# Courtyard enclosure study · closing the conditioned house around the open courtyard · Taif / Palm House V7.1

Design review Y-01 (critical) · 30 Oct 2026 · the windows follow `docs/DESIGN_LANGUAGE.md` (black steel, divided lites)

**DECIDED: option A** (owner, 30 Oct 2026, applied in V7.0): the projection 1.55 m, B3 / R11 / C21–C23 at x 5.80, W1 / W2 / W3 as in § 2. The "now" column below is the V6.3 state (edge x 5.60), kept as the record of the comparison.

# Plans of the gallery strip, first floor · now / A / B · the sky opening and the void · about 1:115 on A4

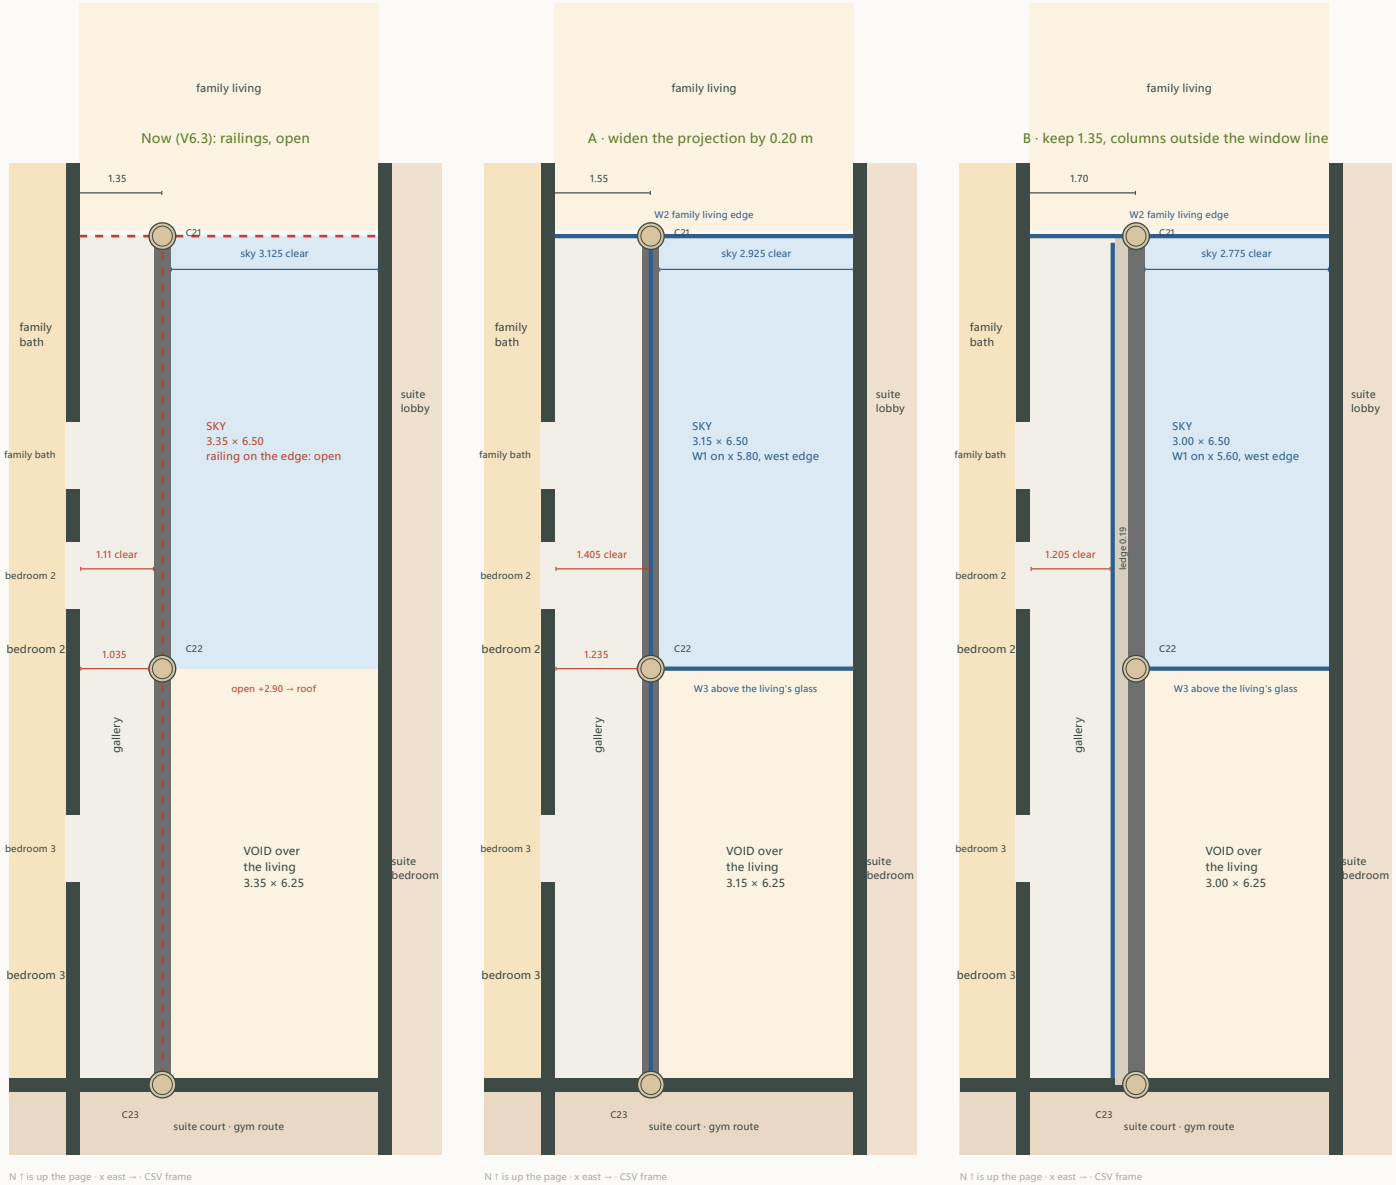
Today the gallery is 1.11 m clear between the rooms' finished wall face (x 4.365) and the upstand of B3, and 1.035 m at the three stone column sleeves (Ø0.4). A window on the line changes little by itself; the columns are the problem. Two ways to reach 1.20 m:

| Item | Now (V6.3): railings, open | A · widen the projection by 0.20 m | B · keep 1.35, columns outside the window line |
|---|---|---|---|
| **Gallery clear · minimum** | **1.035 m** ✗ (< 1.20) | **1.235 m** ✓ | **1.205 m** ✓ |

**4 · Recommendation: A** **A** keeps everything on one line: the beam, the columns, the window and the railing base are the same element, the gallery is 1.405 m clear and 1.235 m at the columns, the sky loses 6 % of its area and stays 3.15 m wide on axes. **B** reaches 1.20 m with no margin (1.205 m), narrows the sky more (3 m: the beam and the roof edge must follow the columns), and adds a 0.35 m ledge outside the glass that must be waterproofed, capped and kept clean; its one real gain, free-standing columns in front of a glass wall, is a stronger colonnade image. If the owner wants that image, B is buildable; otherwise A. In both, the two-storey columns, the upturned B3 and R11 stay as decided (X8); only their x changes. **Study checks passed** (7)

A · widen the projection by 0.20 m · section at y ≈ 10 looking north

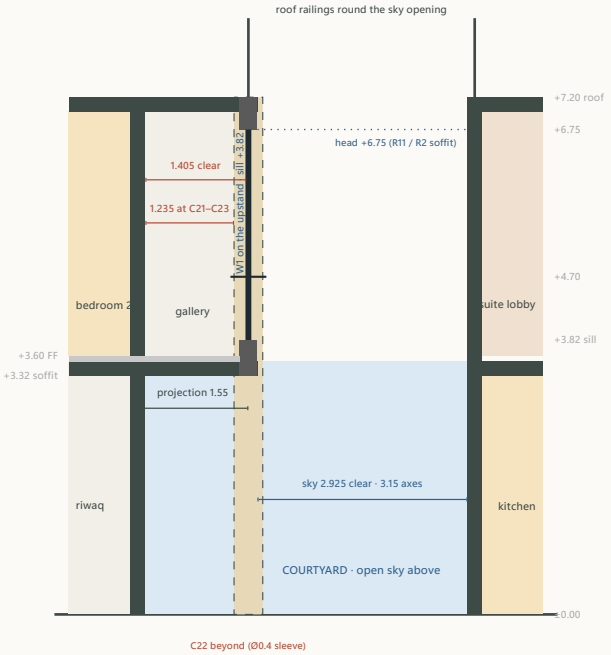
- **A:** B3, R11 and C21–C23 move 0.20 m east to x 5.8 the projection slab bay becomes 1.55 m (slabs-ff row "the projection"), the roof strip over the gallery 1.55 m (slabs-roof); C22 stays the pier in the living's courtyard glass (now at x 5.8), C21 in the women's majlis glass, C23 in the living's south wall; the spans (6.5 / 6.25) are unchanged, R2's west end lands on C22 at x 5.8. The sky opening is 3.15 × 6.5 m.

B · keep 1.35, columns outside the window line · section at y ≈ 10 looking north

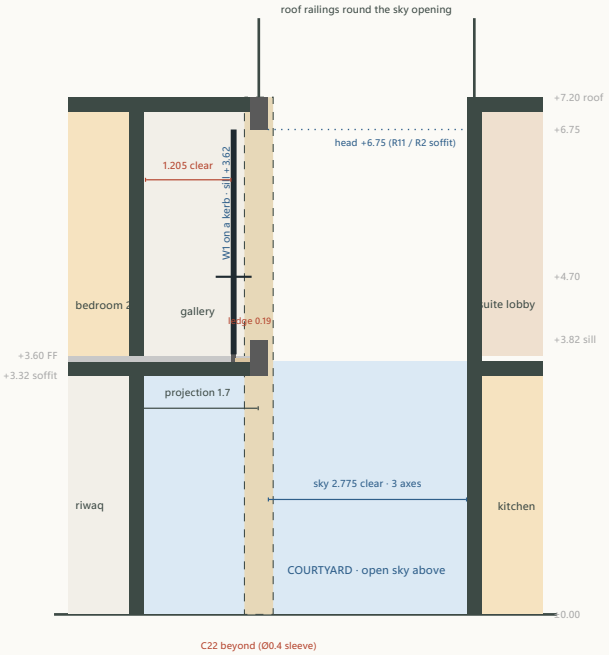
- **B:** B3, R11 and C21–C23 move 0.35 m east to x 5.95 the slab bay becomes 1.7 m with the window line 0.35 m inboard of the beam on a 0.10 m kerb; the ledge between the kerb and the upstand is waterproofed and capped (stone, falling out). The columns stand free in the courtyard and in the void: C22 is a free column in the living's courtyard glass line, 0.35 m in front of the upper window W3 (W3 then runs behind it, from the W1 line at x 5.6 to the kitchen wall, 3.25 m). Alternative B2 (not recommended): B3 stays at x 5.6 and reaches the columns at x 5.95 on short corbels; two lines of concrete for one edge.

# W1 · the gallery line seen from the courtyard and the void (looking west) · option A · 1:70 on A4

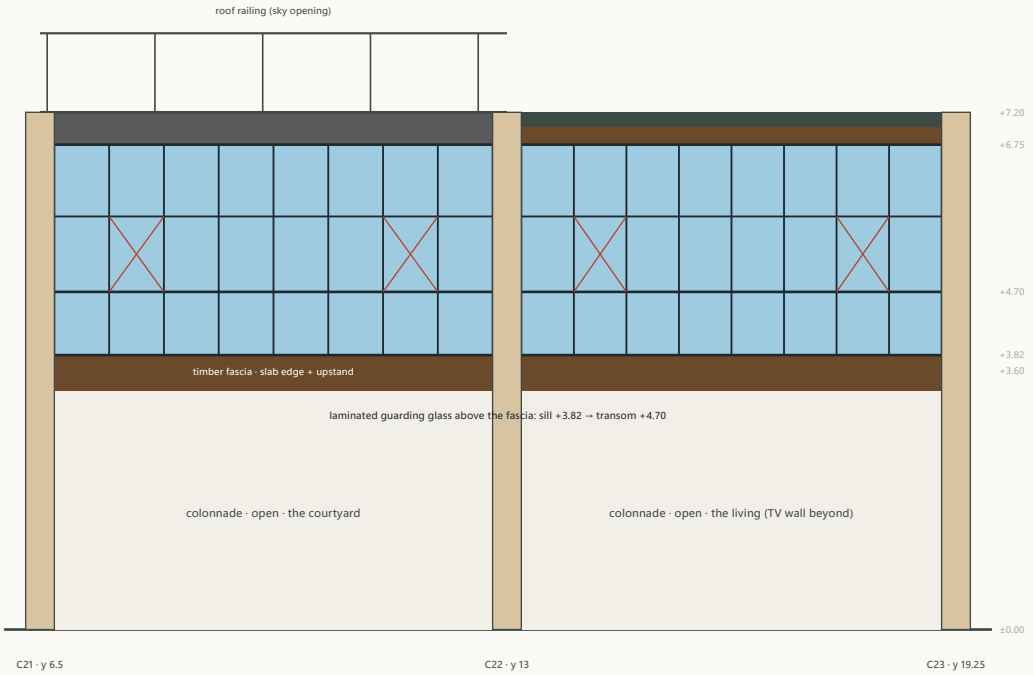
| Window | Line | Sill | Head | Lites and operation |
|---|---|---|---|---|
| W1 gallery edge | x 5.8 (A) / 5.6 (B), y 6.5–19.25 | +3.82 (upstand) | +6.75 | guarding transom at +4.70 (1.10 above the floor), laminated glass below it; above it lites ≈ 0.75 wide; one inward side-hung casement per bay (two bays, four casements) for calm nights and cleaning |

**Cleaning from inside.** W1: both faces from the gallery: the inside directly, the outside through the open casements (every lite within an arm's reach of a casement, the glass height 2.93 m). W2: as W1 from the family living. W3: the inside from the living floor with a water-fed pole (top +6.75); the outside from the courtyard floor with the same pole (6.75 m) or from the gallery's casement at its west end. The courtyard floor's hose point (Y-04) serves the pole. **Frames.** Black steel, thermally broken, divided lites, double low-e glass, dust seals, insect screens on the casements. Depth ≈ 0.06 m on the line; the stone column sleeves stop at the frame with a sealed joint (A) or stand free (B).

**V7.1 (owner, 31 Oct 2026): semicircular heads and the courtyard arcade.** Every enclosure window gets a semicircular (Roman) arched head in black steel with divided lites, the arched head fixed, the rectangular part below with the operable lites; the sill and the guarding transom (+4.70) as in § 2. **W1:** six arched windows 1.60 m wide on the gallery edge, three per column bay, sill +3.82, springing +5.80, crown +6.60, 0.15 m of wall below the R11 / R2 soffit (+6.75): in the courtyard bay they stand over the three bays of the new arcade (y 6.783–8.383, 8.950–10.550, 11.117–12.717), in the void bay on three equal bays (13.242–14.842, 15.325–16.925, 17.408–19.008); the four casements sit in the lower parts. **W2:** two arched windows 1.30 m wide east of C21 (x 6.00–7.30 and 7.55–8.85), floor to the crown +6.60, springing +5.95; the strip x 4.25–5.80 of that edge is the family living's opening to the gallery's north end, no window. **W3:** one arched window 2.80 m wide (the whole space between C22's stone sleeve and the east wall; the brief said ≈ 3.0) over the living's courtyard glass, +3.32 to the crown +6.60, springing +5.20, the two motorised tilt lites in its lower part; 0.15 m of wall to the R2 soffit. **The arcade:** in the courtyard bay only, two slender honey-stone columns Ø0.25 on x 5.80 at y 8.667 and 10.833 (three equal bays of 2.167 m on axes) with three semicircular arch plates under the projection's soffit (+3.27): spans 1.84 / 1.92 / 1.84 m between the sleeves, springing +2.35 / +2.31 / +2.35, crown +3.27; decorative unless the engineer uses the columns (`studies/structure.typ` X18); the living bay keeps no arches. The columns stand 0.78 m clear of the sunken seating's west edge, 1.36 m clear of the riwaq door's swing line, 1.33 m from the riwaq glass face; the malqaf outlet is on the east wall. The courtyard reads as a two-tier arcade: three arches below, three arched windows above.
